ACCESSION NBR: 8201290423 DOC. DATE: 82/01/19 NOTARIZED: NO DOCKET #  
 FACIL: 50-397 WPPSS Nuclear Project, Unit 2, Washington Public Power 05000397  
 AUTH. NAME: AUTHOR AFFILIATION:  
 BOUCHEY, G.D. Washington Public Power Supply System  
 RECIP. NAME: RECIPIENT AFFILIATION:  
 SCHWENCER, A. Licensing Branch 2

SUBJECT: Forwards resolution re fuel design & plant operation, per  
 820106 telcon. Response answers Core Performance Branch  
 concerns re channel box deflection, waterside corrosion,  
 seismic LOCA leads analysis & online fuel failure detection.

Subject: NUCLEAR PROJECT NO. 2  
CORE PERFORMANCE BRANCH CONCERNS,  
RELATED DURING PHONE CALL JANUARY 6, 1982

FIGURE 1 WNP-2 INITIAL CORE FUEL ASSEMBLY ENRICHMENT  
 DISTRIBUTION MAP - HIGH ENRICHMENT BUNDLE

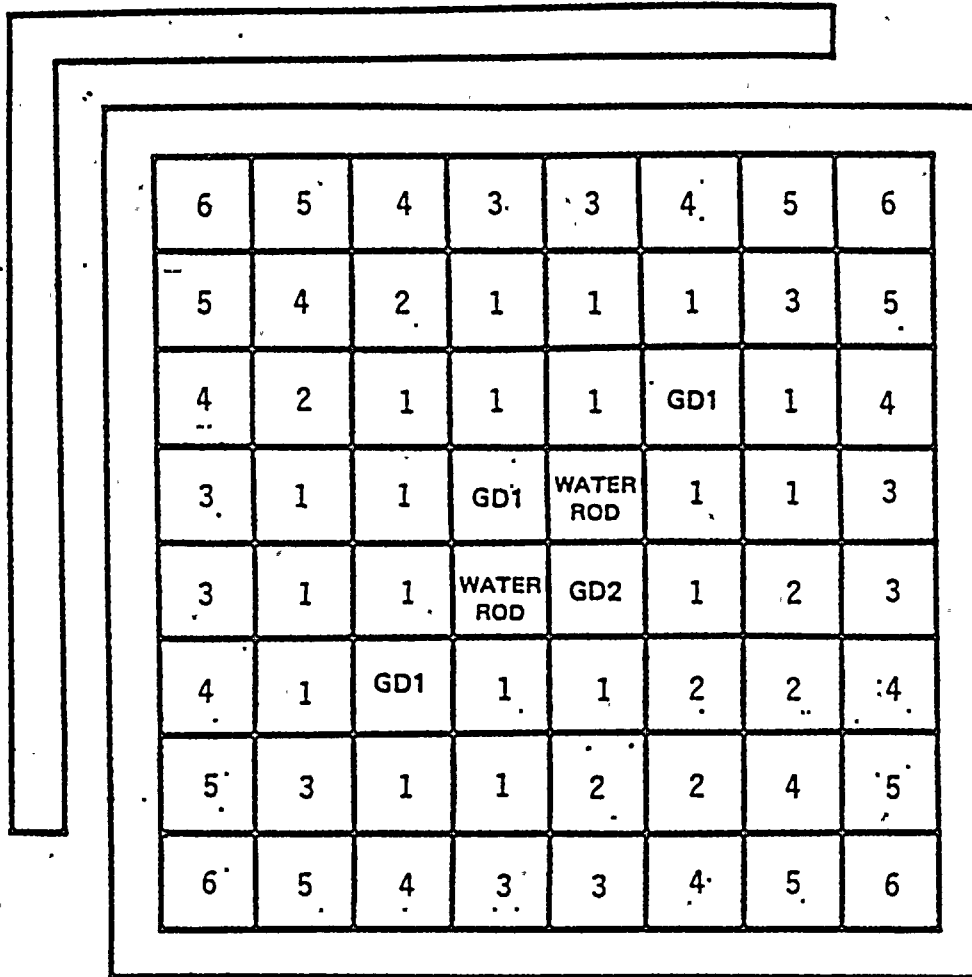
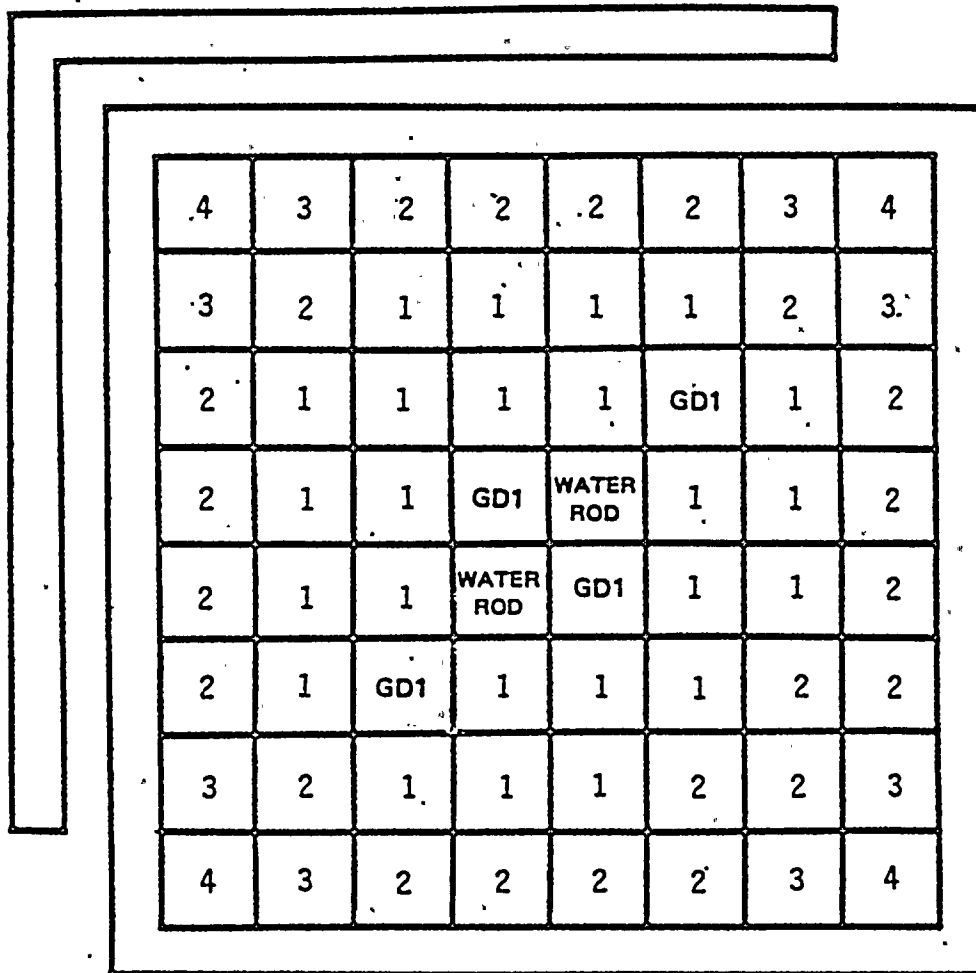
7. Additional Information in the Initial Core Fuel Design - The FSAR section describing the initial WNP-2 fuel design references a GE document that is presently out of date. WNP-2 and the NRC recognize that the appropriate GE document will not be available from GE until mid-January, 1982. In the interim the following information is forwarded for NRC review:

"The WNP-2 initial core fuel bundles contains 62 fuel rods and 2 water rods. The fuel rods are helium backfilled to 3 ATM. This design is designated by General Electric as P8X8R meaning the fuel rods are pre-pressurized, the bundle has a 8 by 8 rod configuration (total of 64 rods) and the bundle is what is called a retrofit design.

For the WNP-2 core, Table 1 gives general fuel rod parameters that describe the WNP-2 fuel. The three bundle types shown in Figures 1, 2 and 3 are loaded in a C-Lattice configuration in the quarter core pattern shown in Figure 4.
